City of Avondale Estates
Planning Architectural Zoning Board
Staff Review, Variances *

November 17, 2025, PAZB Meeting

Applicant: 278 Oak Holdings LLC: Jetha Wagner, Avila Development

Property Address: 136 Laredo Drive, 2968 Parry Street, 147 Oak Street, 2950 Franklin Street, and 2556 Franklin Street (Oak Parcel)

NEW STREET A

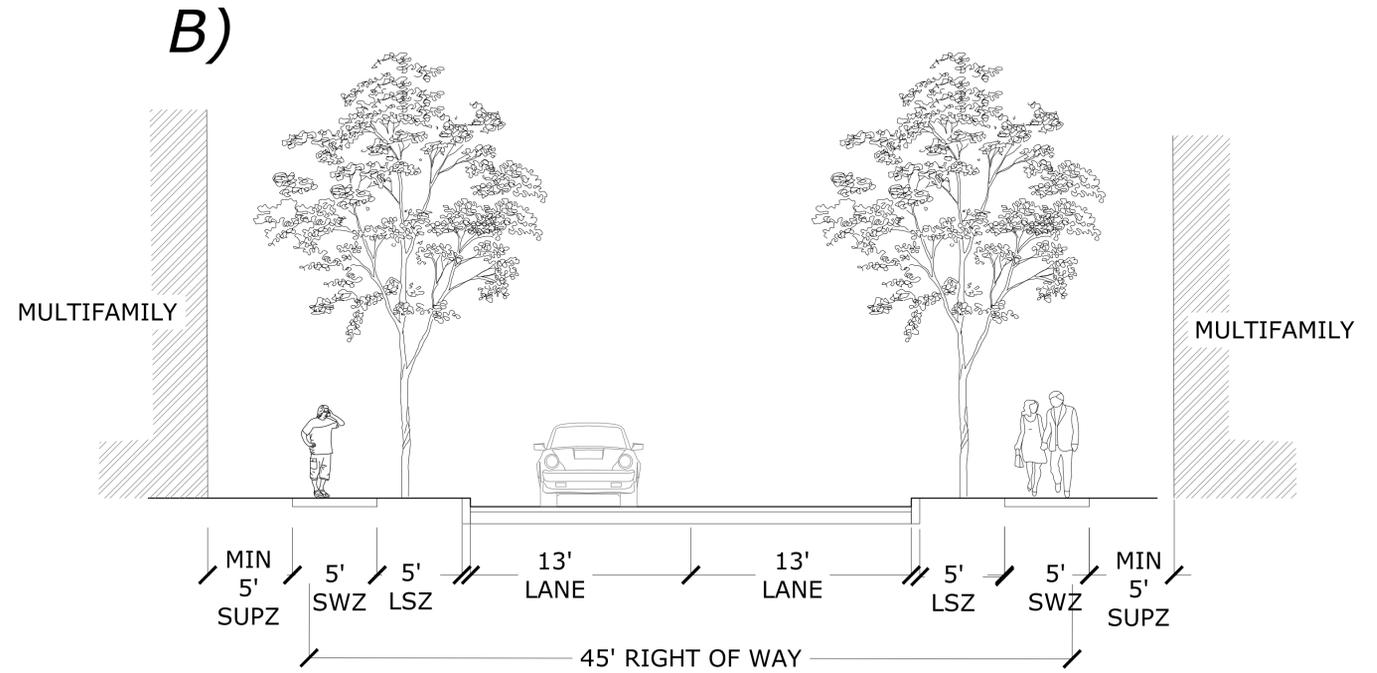
FROM: Figure 21-3.2.8.B.4.b and Table 3.2.8.E reduce type B2 street section from 60' ROW and 5' SUPZ to building face.

TO: New Street A proposed street section with 45' ROW and 5' SUPZ to building face per section in Exhibit D.

NEW STREET B

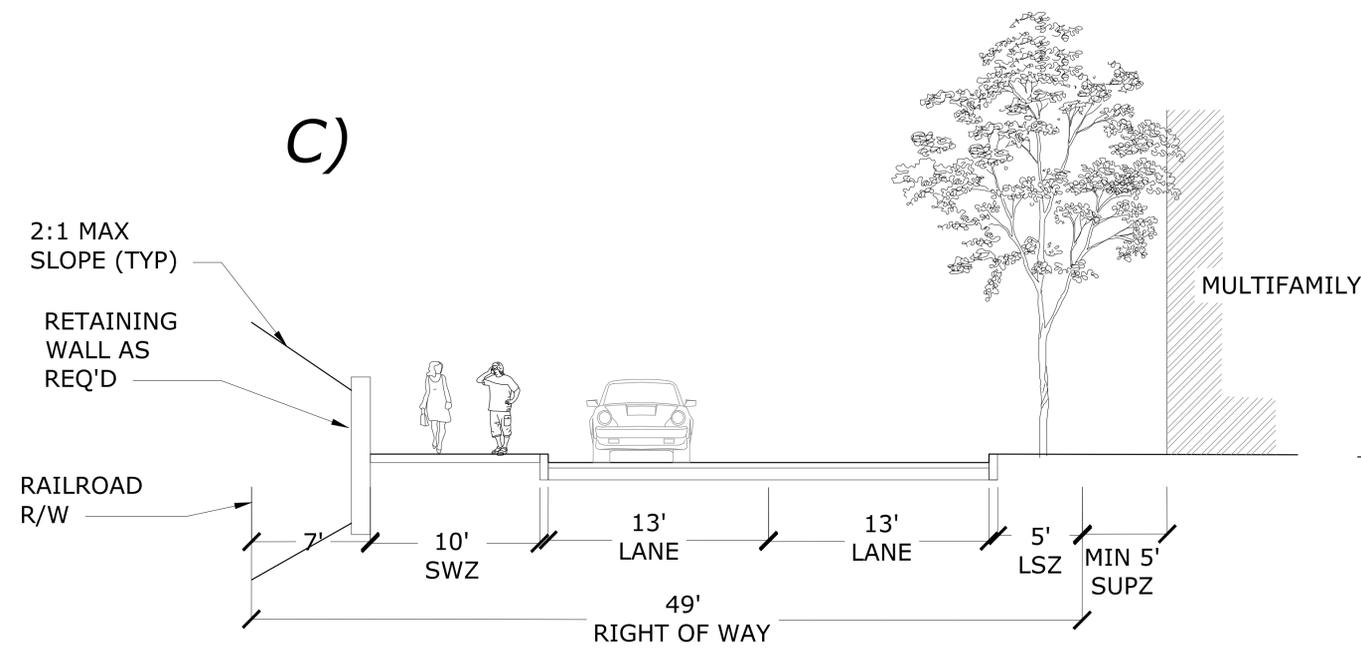
FROM: Figure 21-3.2.8.B.4.b and Table 3.2.8.E reduce type B3 street section from 45' ROW, 3' LSZ and 5' SUPZ to building face.

TO: New Street B proposed street section with 45' ROW, 1' SWZ and 5' SUPZ to building face per section in Exhibit D.

NEW STREET C

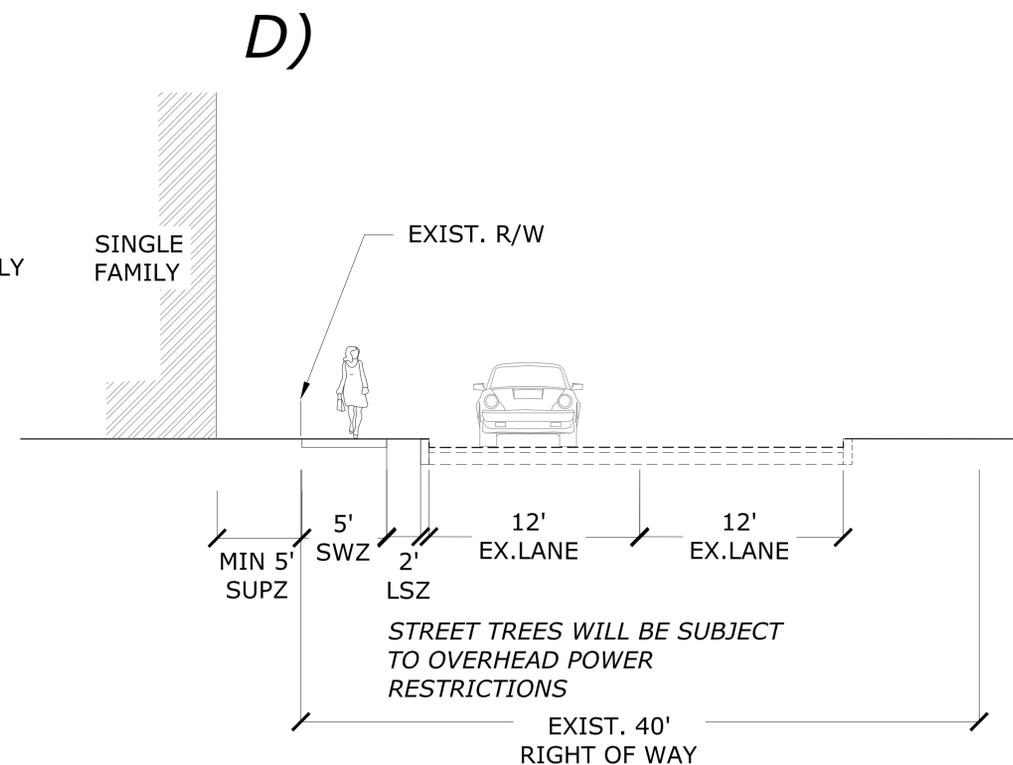
FROM: Figure 21-3.2.8.B.4.c and Table 3.2.8.E reduce type C1 street section from 55' ROW and 5' SUPZ to building face.

TO: New Street C proposed street section with 49' ROW and 5' SUPZ to building face per section in Exhibit D.

CENTER STREET-EXTERNAL

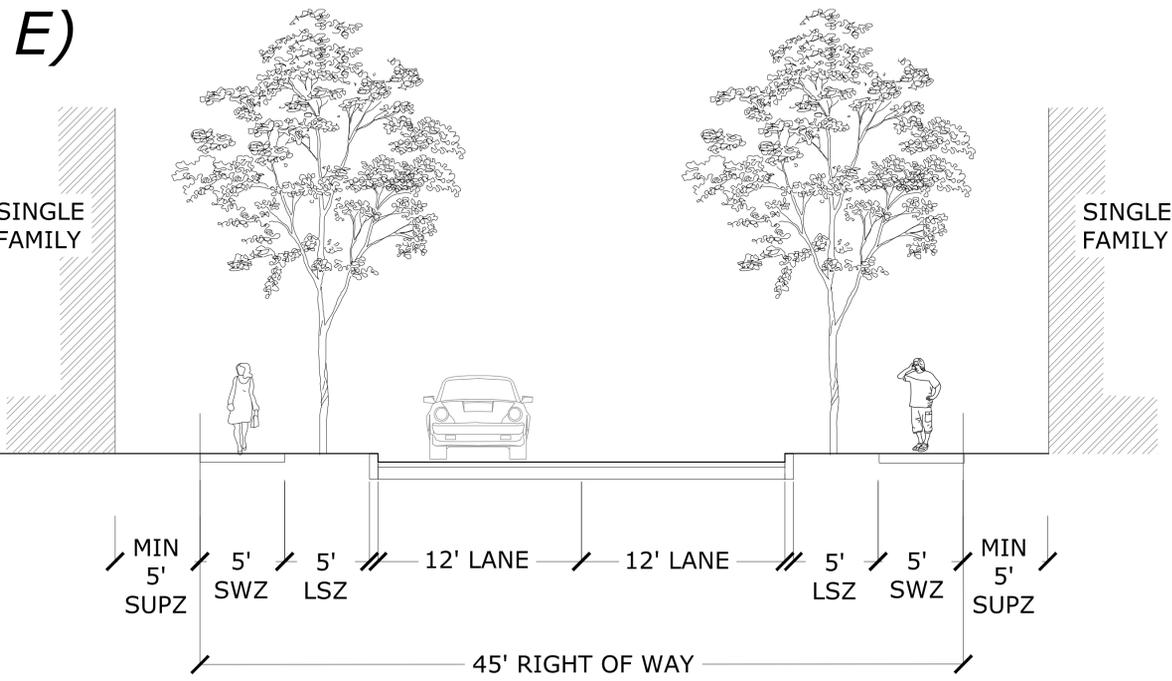
FROM: Figure 21-3.2.8.B.4.c and Table 3.2.8.E reduce type C2 street section from 40' ROW and 5' SUPZ to building face.

TO: Center Street-External section with 40' ROW and 5' SUPZ to building face per section in Exhibit D.

CENTER STREET EXTENSION

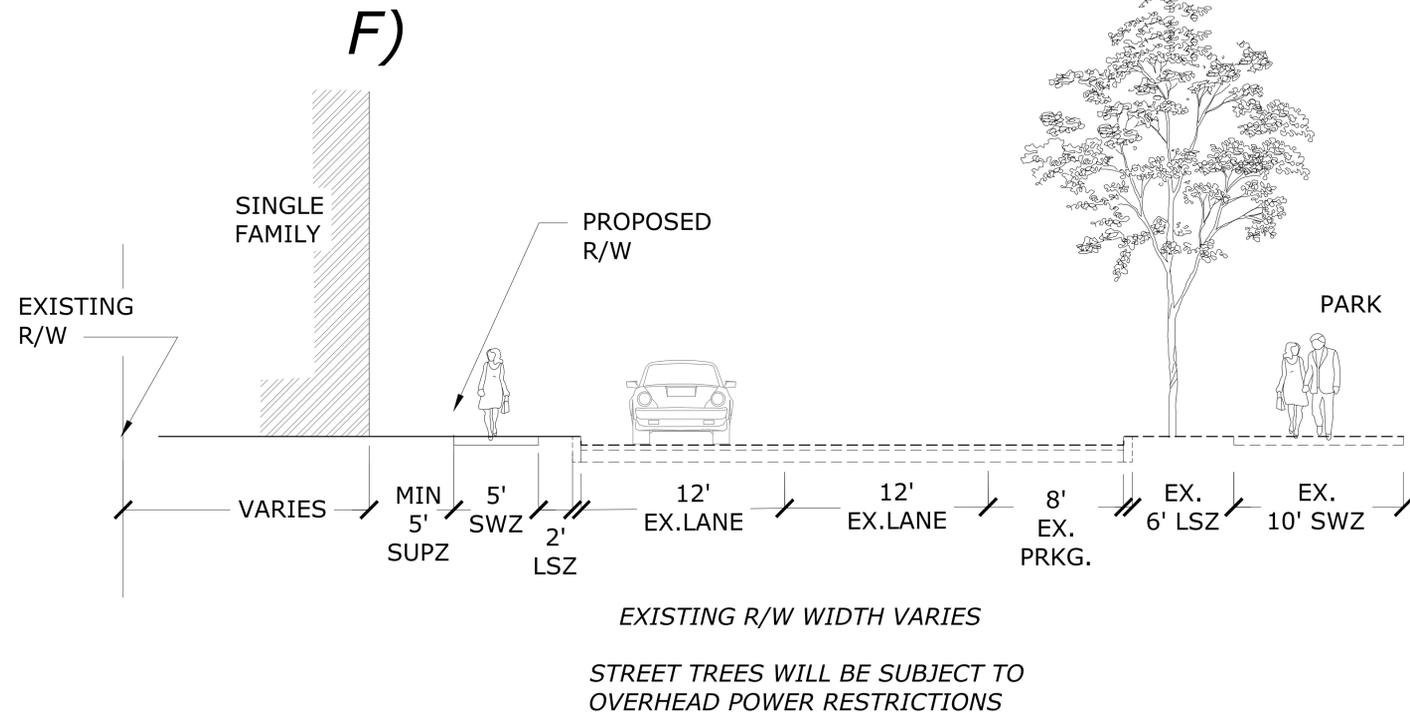
FROM: Figure 21-3.2.8.B.4.c and Table 3.2.8.E reduce type C1 street section from 55' ROW and 5' SUPZ to building face.

TO: Center Street-Extension section with 45' ROW and 5' SUPZ to building face per section in Exhibit D.

WASHINGTON STREET

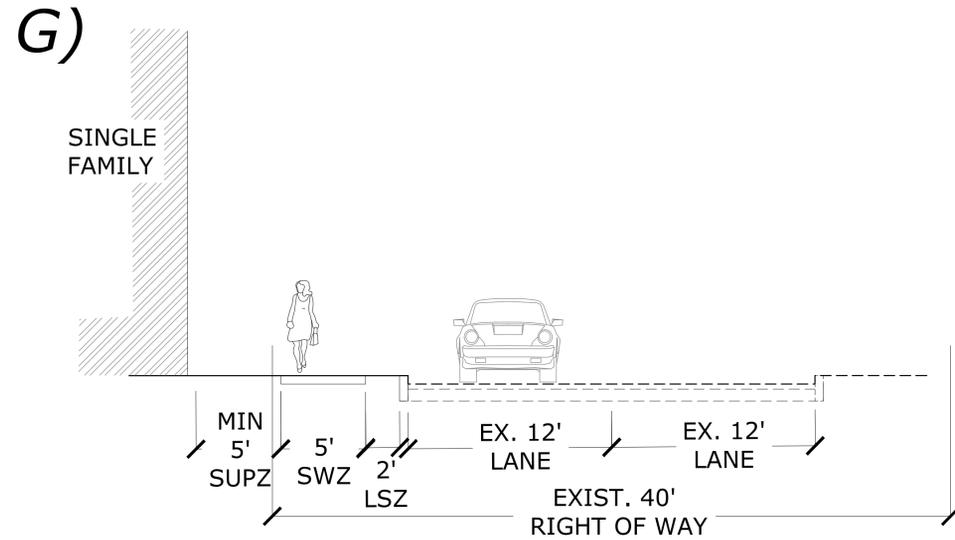
FROM: Figure 21-3.2.8.B.4.b and Table 3.2.8.E reduce type B1 street section from 72' ROW and 5' SUPZ to building face.

TO: Washington Street -existing varied section with 55' ROW and 5' SUPZ to building face per section in Exhibit D.

FRANKLIN STREET

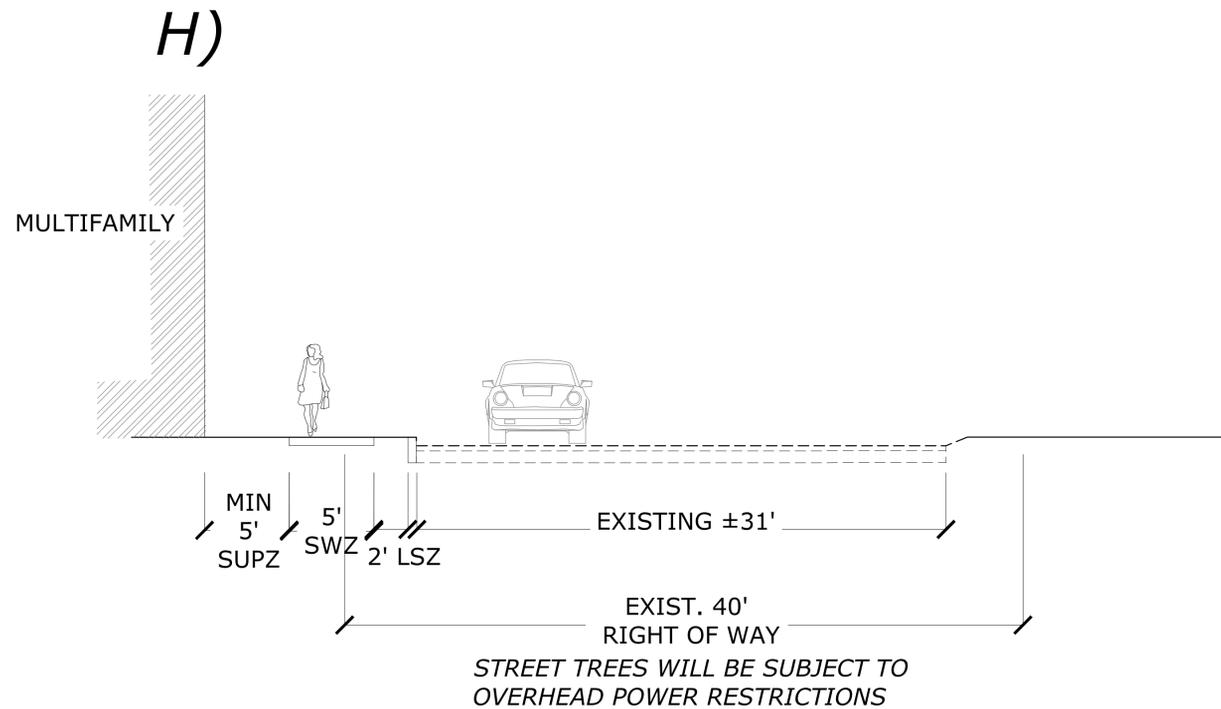
FROM: Figure 21-3.2.8.B.4.d and Table 3.2.8.E reduce type D street section from 40' ROW and 5' SUPZ to building face.

TO: Franklin Street -existing varied section with 40' ROW and 5' SUPZ to building face per section in Exhibit D.

Figure 3.2.12.F - Transitional Height Plane

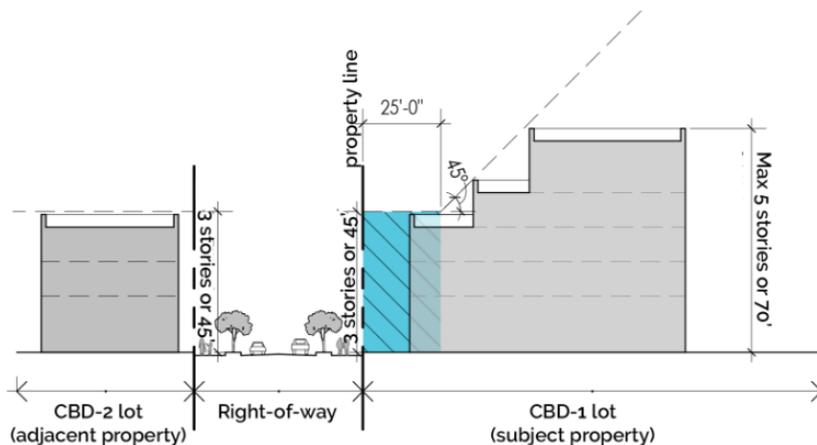
DESIGN TEAM NOTE: This requirement impacts the Southeastern corner of the Maple Street site, which abuts the CBD-2 district across Olive Street. This would limit that portion of the building to 3-stories (instead of 5) which could eventually step up to 5-stories. See Figure 3.2.12.F below. Need to be allowed 5-stories (plus basement) in all locations – including areas where transitional height plan comes into play.

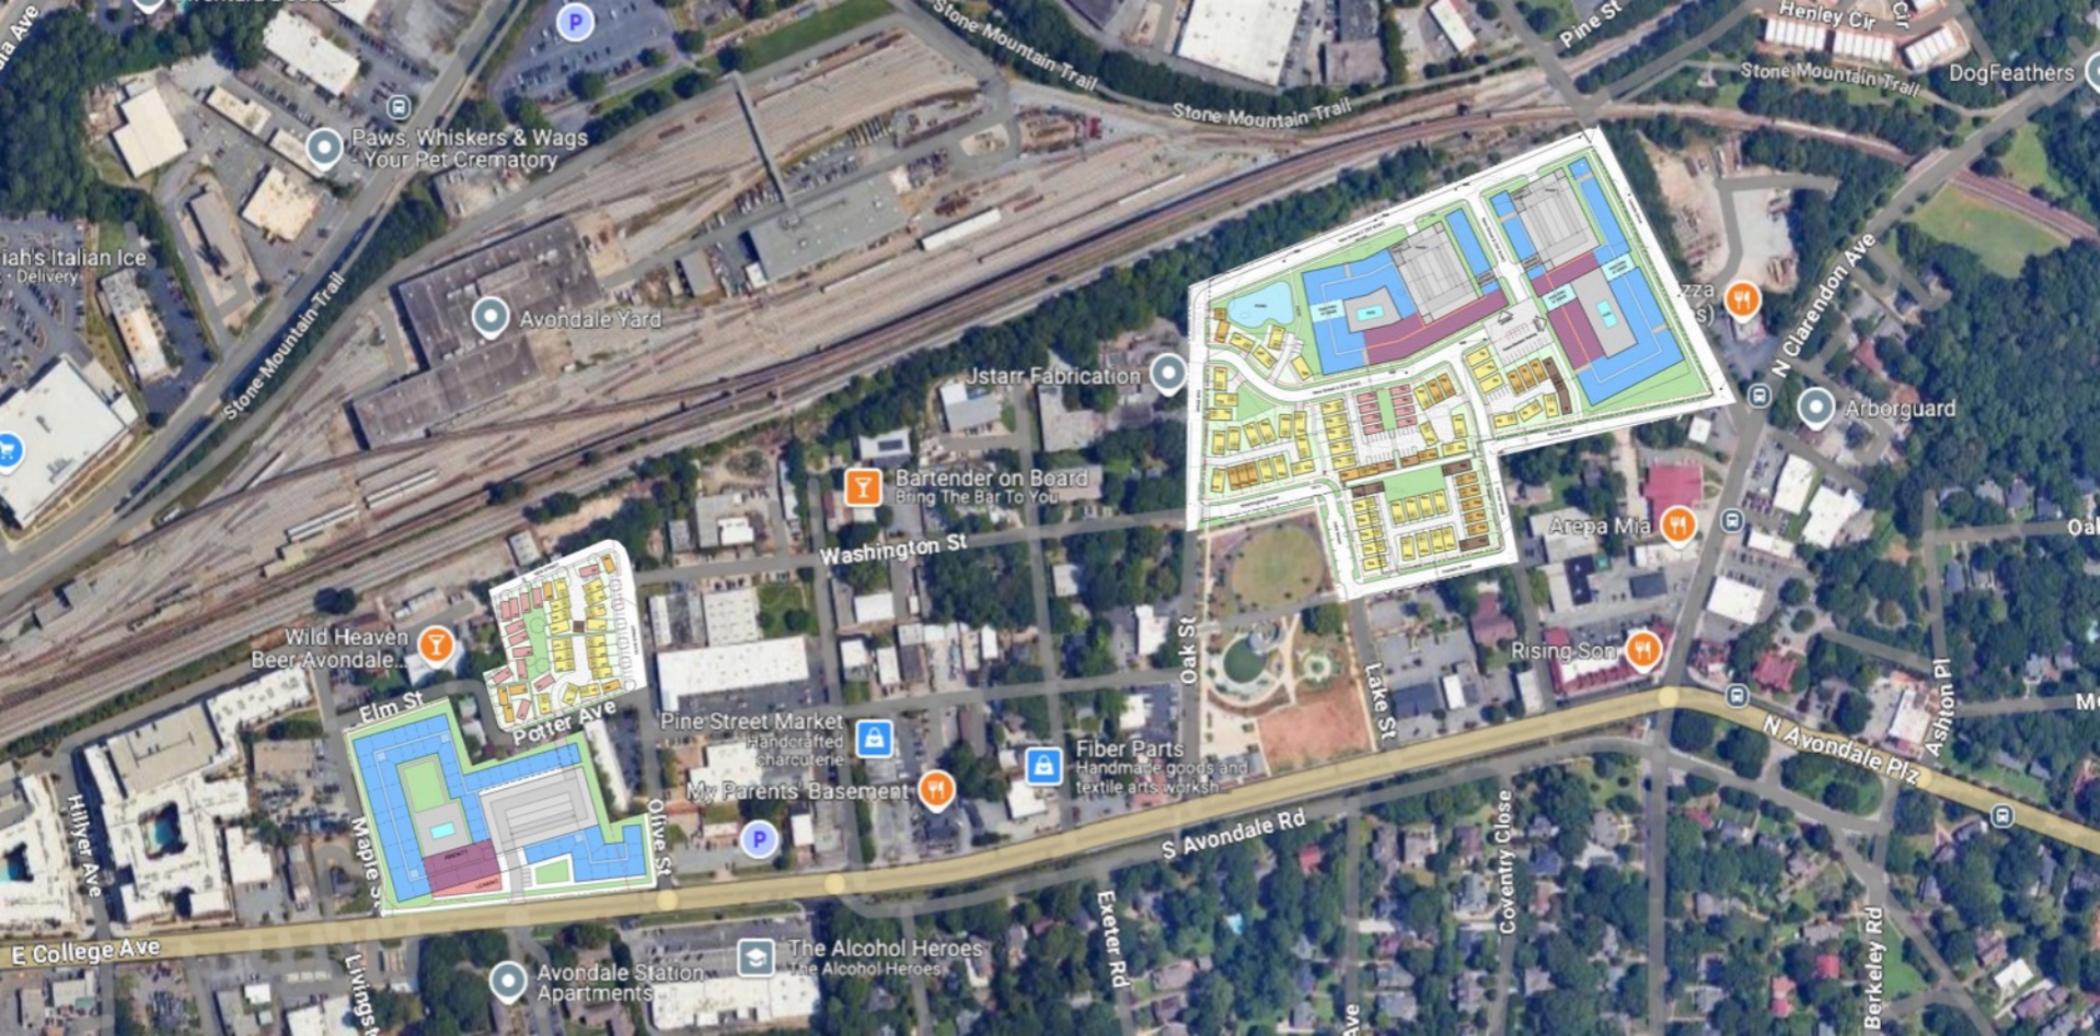
DESIGN TEAM NOTE: Based on this requirement, each MF building would be required to have 5-7 loading spaces. Need to reduce this down to 1 loading spaces per building.
